# Intel Technical Advisory

TA-1005-1

## Intel® Integrated RAID Module rework to resolve an AC power cycling cache backup issue

**Figure 1. The jumper wire on Intel® Integrated RAID Module RMS25PB080, RMS25PB040 and RMT3PB080**

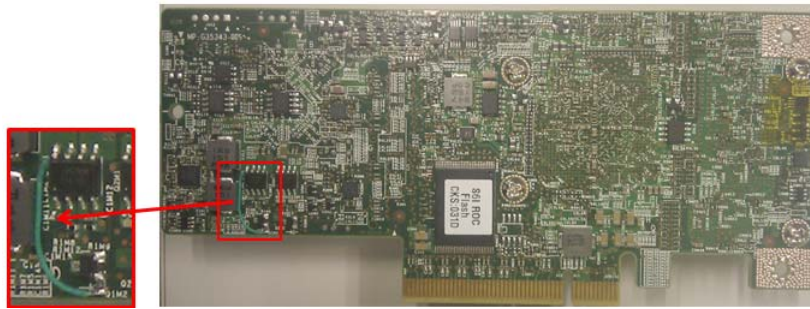
The PCB's (Print Circuit Boards) for the controllers listed above are being modified to resolve an AC power cycling cache backup issue with the Intel® RAID Smart Battery AXRSBBU9 and the Intel® RAID Maintenance Free Backup Unit AXRMFBU2 cache backup solutions. In addition to some minor component changes a jumper wire will be added to the PCB's during manufacturing. Intel has completed process and product qualification for the changes to verify that there is no impact to product quality and reliability.

See the photos below of the jumper wire on the Intel® Integrated RAID Modules:

The component changes and jumper wire are an interim solution. A new version of the PCB has been designed that incorporates the necessary changes and product based on the new PCB is scheduled for availability in July 2012. Intel does not anticipate any functional or quality impact with the jumper wire solution. If the jumper wire solution is not acceptable, please order the new modules with the changes designed into the PCB solution, new MM# for the new revision of these products are listed below.
